**FAN DRIVE OF ENGINE TYPE 503****INTRODUCTION OF A NEW FAN WITH MATCHING PROTECTION WASHER**

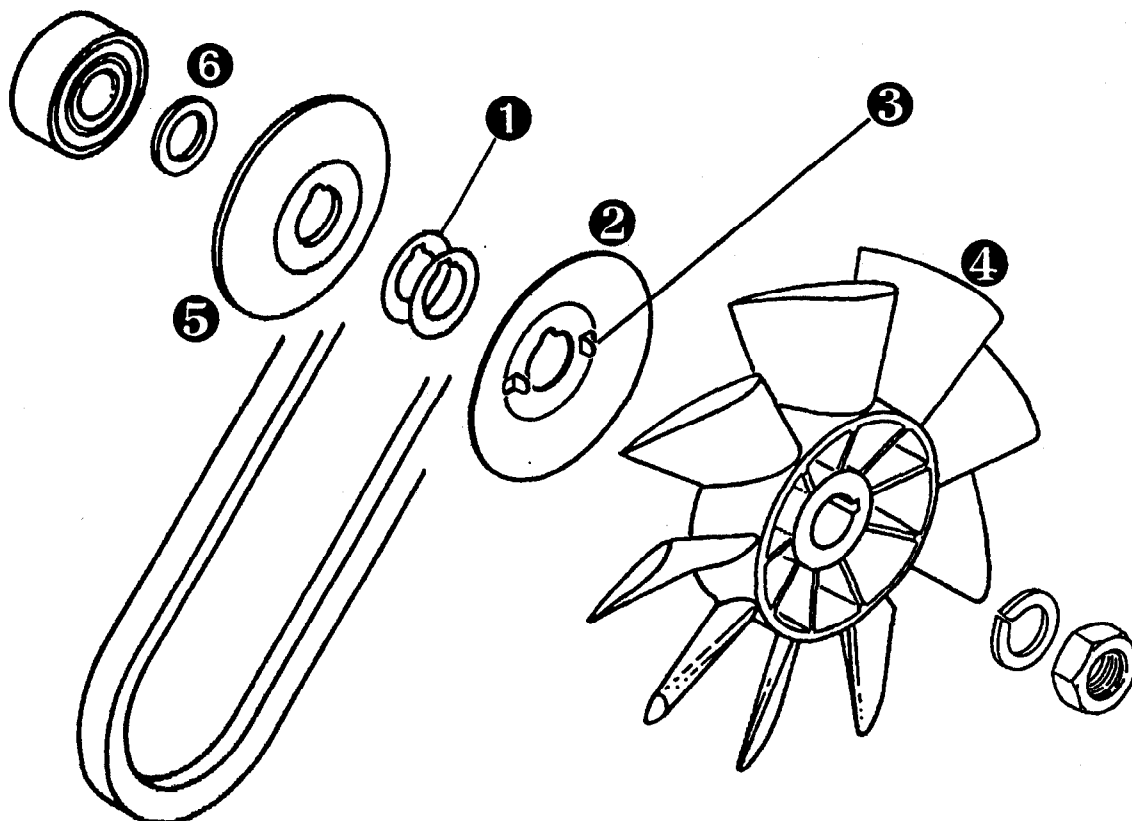
1) In order to avoid that shims ① necessary for adjustment of the fan belt tension be fitted in a wrong position (e.g. between protection washer and fan), a new fan and protection washer has been introduced from engine serial no. 3,787.952.

2) The new protection washer ② has 2 positioning noses ③ which engage in the 2 bores of the new fan ④. These 2 noses prevent that shims be fitted between fan and protection washer.

3) The new fan is interchangeable with the old one as spare part.

4) The new protection washer ② can only be fitted together with the new fan.

5) The protection washer used previously (without positioning noses) can be used for both the old and new fan version.

6) The shims ① needed for adjustment of the fan belt tension have to be placed between pulley half ⑤ and the protection washer ②. Shims which are not needed for tensioning should be placed between pulley half ⑤ and distance sleeve ⑥.
